SUBJECT: HOPE CREEK GENERATING STATION, FACSIMILE TRANSMISSION,
ISSUES TO BE DISCUSSED IN AN UPCOMING CONFERENCE CALL
(TAC NO. MA6342)

Issues for Discussion in Upcoming Telephone Conference
Related to PSE&G License Change Request H99-08, dated August 26, 1999
Raise Condensate Storage Tank Low Level Setpoint

FIGURE 1
Determination of CST Minimum Operational Level

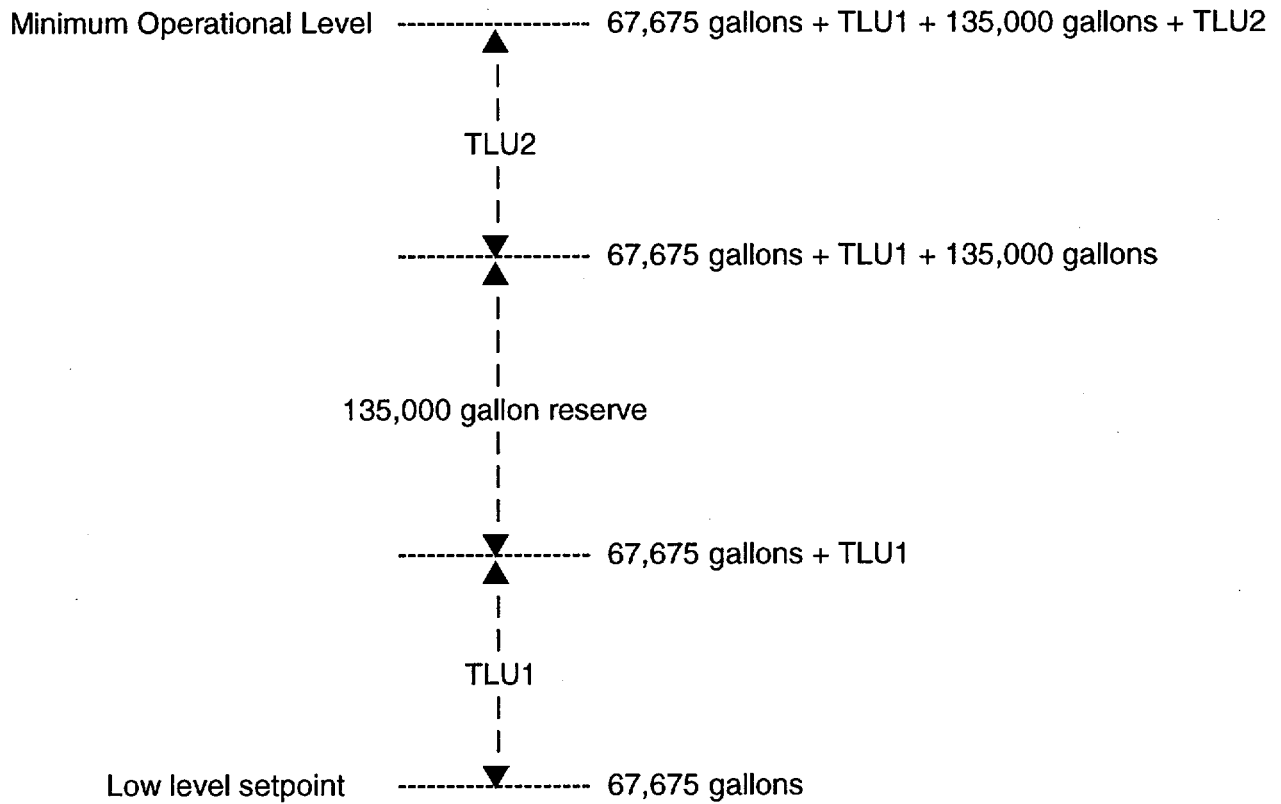
Given the information described above, it is not clear if sufficient instrument uncertainties were accounted for in establishing the minimum operational CST level (i.e., 203,000 gallons) in order to ensure that the 135,000 gallon design basis value will be maintained.

- 1) What is the total instrument loop uncertainty (in gallons) on the CST low level setpoint of 67,675 gallons?
- 2) What instrumentation is used by the ensure that the minimum operational CST level of 203,000 gallons is maintained?
- 3) What is the total instrument loop uncertainty (in gallons) of the instrumentation used in question (2)?
- 4) What instrument uncertainties (e.g., basic accuracy, setting tolerance, maintenance and test equipment, temperature effects) were included in the total loop uncertainty calculations for the instrumentation in questions (1) and (3)?
- 5) What process effects (if any) were included in the total loop uncertainty calculations in questions (1) and (3)?

Note, Figure 1 depicts how the minimum operational CST level could be determined by taking the appropriate uncertainties into account.
